**SUBJECT:** NuScale Power, LLC Supplemental Response to NRC Request for Additional Information No. 83 (eRAI No. 8899) on the NuScale Design Certification Application

NuScale Supplemental Response to NRC Request for Additional Information eRAI No. 8899

**eRAI No.:** 8899

**NRC Question No.:** 19.01-14

Figure 19.1-42: Simplified Reactor Building Section View

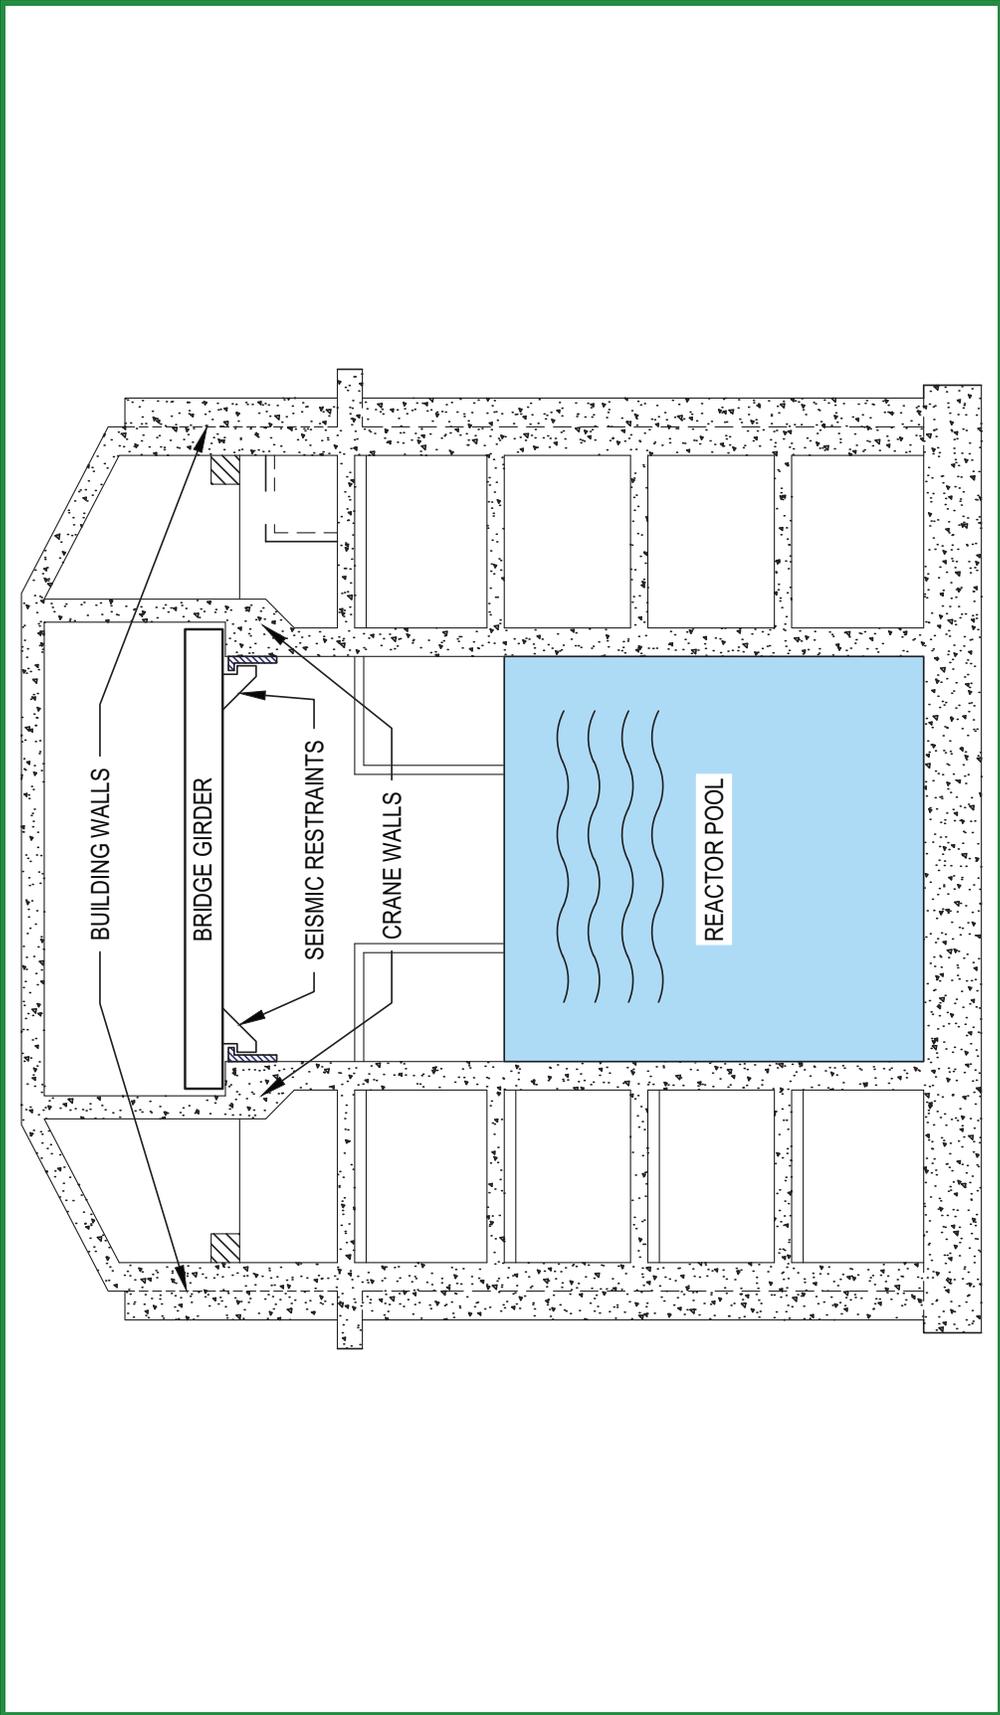
The HCLPF capacity provided in the FSAR corresponds to the higher HCLPF capacity (in row 1 above) supplied by the contractors. The failure modes considered are for the bridge and trolley seismic restraint assemblies. The controlling HCLPF capacity is determined to correspond to the seismic bridge restraint weldment.

A note is provided below Table J.10 in relation to the lower HCLPF capacity (in row 2 above). The note states that “The fragility for the reactor building crane is with respect to a bridge girder failure in shear. Upon further evaluation, catastrophic bridge girder failure will be preceded by bridge seismic restraint failure. Due to this realization, failure of the bridge seismic restraints are the controlling failure mode, rather than the bridge girder.” This information is also summarized in Section 19.1.5.1.1.3, Subsection “Reactor Building Crane.”

Based on the staff’s review of ER-P-040-7026-R0, Appendix J, during its audit of the PRA (ML17087A109), the staff needs additional information to understand the basis for eliminating bridge girder failure in shear as a controlling failure mode for the RBC fragility evaluation. Because the RBC is PRA-critical and controls the plant level HCLPF capacity, the staff requests that the applicant provide further justification for eliminating the bridge girder failure in shear in the RBC fragility evaluation.

NuScale has evaluated the potential for "bridge girder failure in shear" as well as "catastrophic bridge girder failure". Girder failure in shear implies that the girder exhibits inelastic deformation, but remains on top of the crane walls because of the span of the girders. Fragility for the bridge girders is calculated up to the yield strength of the girder materials. Any induced buckling or torsion short of complete girder shearing, while potentially rendering the crane inoperable, cannot cause the bridge structure to collapse as long as the seismic restraints hold.

Catastrophic bridge girder failure is associated with a seismically-induced vertical jumping motion that is sufficient for the crane bridge to decouple from the rail and slide off the crane wall ledges; the seismic restraints are designed to resist this motion. Analysis shows that seismic restraint failure is the controlling seismic failure mode for the crane collapse and, thus, is reported as the controlling failure mode in FSAR Section 19.1.5.1.1.3 and FSAR Table 19.1-35.

FSAR Section 19.1.5.1.1.3 has been modified to reflect consideration of both failure modes. FSAR Figure 19.1-42 has been added to illustrate the bridge girder, crane wall ledges and seismic restraints.

The crane is designed with seismic restraints. ~~Catastrophic~~ As illustrated in Figure 19.1-42, -bridge girder failure is preceded by failures of these bridge seismic restraints through yielding of the restraint weldments ~~bridge girder failure cannot lead to catastrophic collapse without failure of the bridge seismic restraints.~~ Therefore, failure Failure of the bridge seismic restraints is the controlling failure mode by comparison to yielding of the bridge girder itself. The bounding consequence of crane failure is a collapse of the crane structure, which is assumed to impact the top of the module, and lead to core damage and large release. This modeling simplification is ~~required~~ conservative because the bioshield, CNV and RPV integrity are not credited following a crane collapse.
